CITY OF VAUGHAN

EXTRACT FROM COUNCIL MEETING MINUTES OF JUNE 25, 2024

5. 2678463 ONTARIO LTD. (CORTEL GROUP) OFFICIAL PLAN AMENDMENT FILE OP.24.002 ZONING BY-LAW AMENDMENT FILE Z.24.006 DRAFT PLAN OF SUBDIVISION FILE 19T-16V009 SITE DEVELOPMENT FILE DA.19.016 VICINITY OF HIGHWAY 7 AND BOWES ROAD

**TITLE: 2678463 ONTARIO LTD. (CORTEL GROUP)
OFFICIAL PLAN AMENDMENT FILE OP.24.002
ZONING BY-LAW AMENDMENT FILE Z.24.006
DRAFT PLAN OF SUBDIVISION FILE 19T-16V009
SITE DEVELOPMENT FILE DA.19.016
VICINITY OF HIGHWAY 7 AND BOWES ROAD**

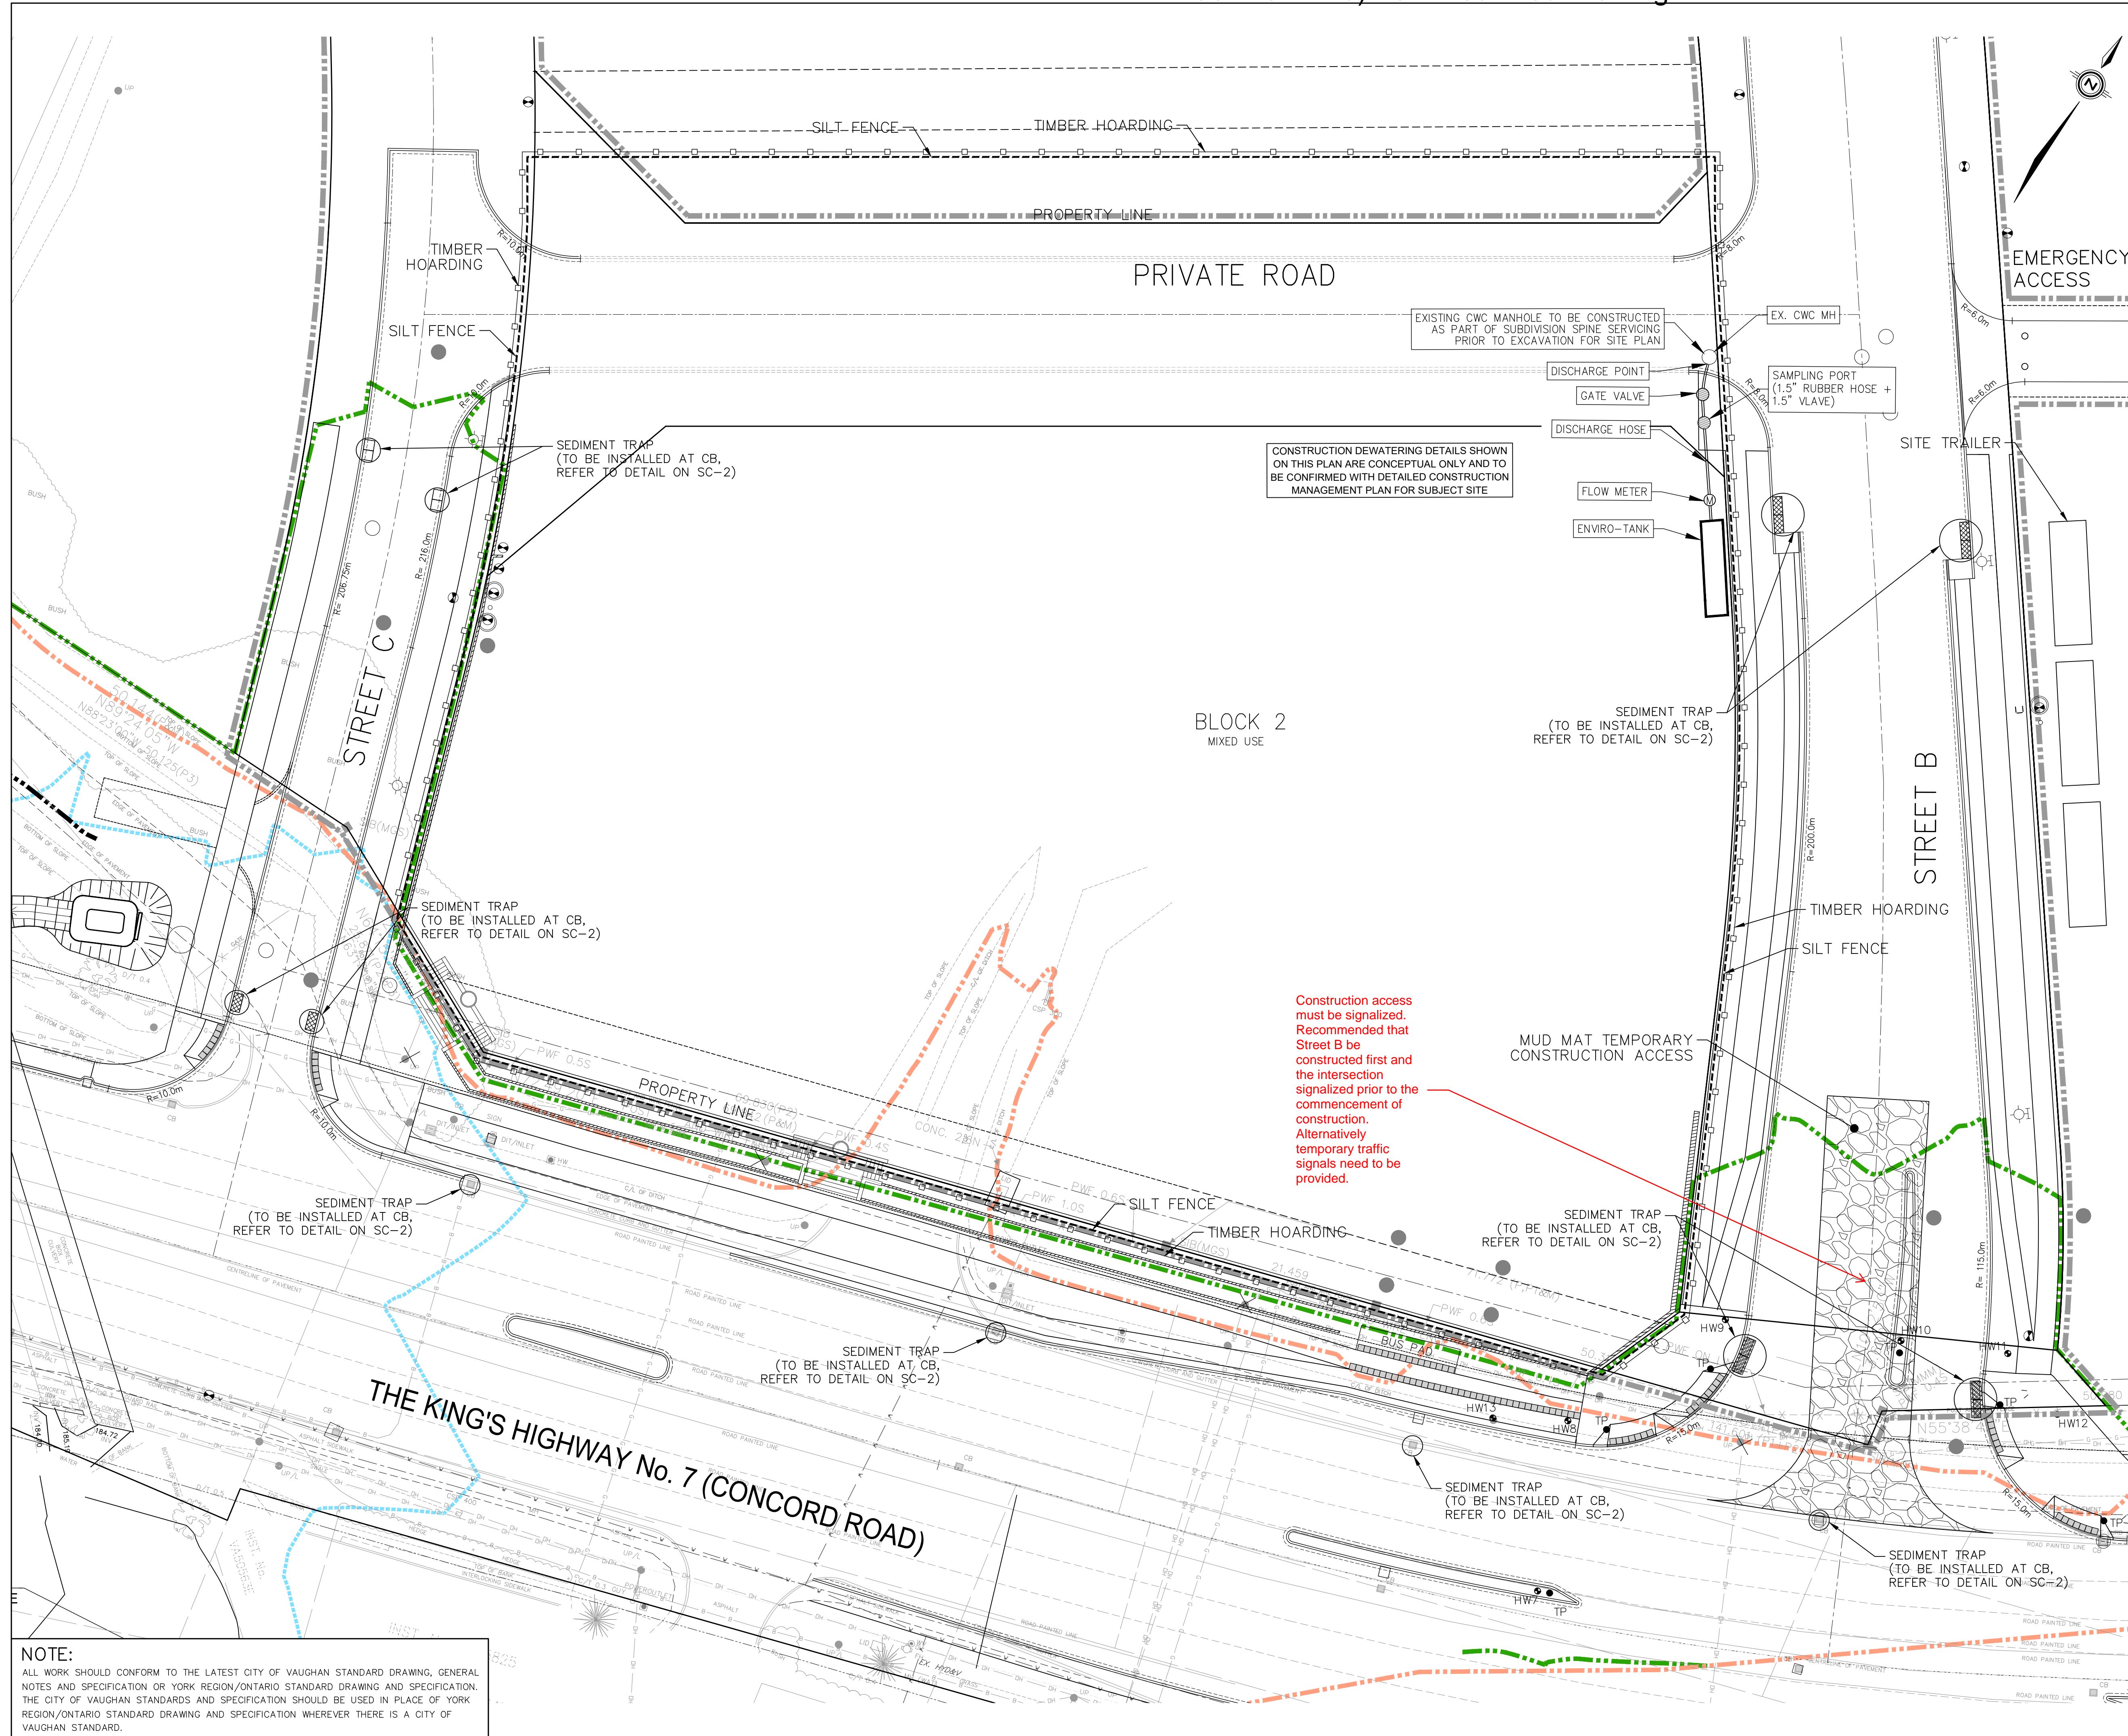
Construction access must be signaled. Recommended that Street B be constructed first and the intersection signaled prior to the commencement of construction. Alternatively temporary traffic signals need to be provided.
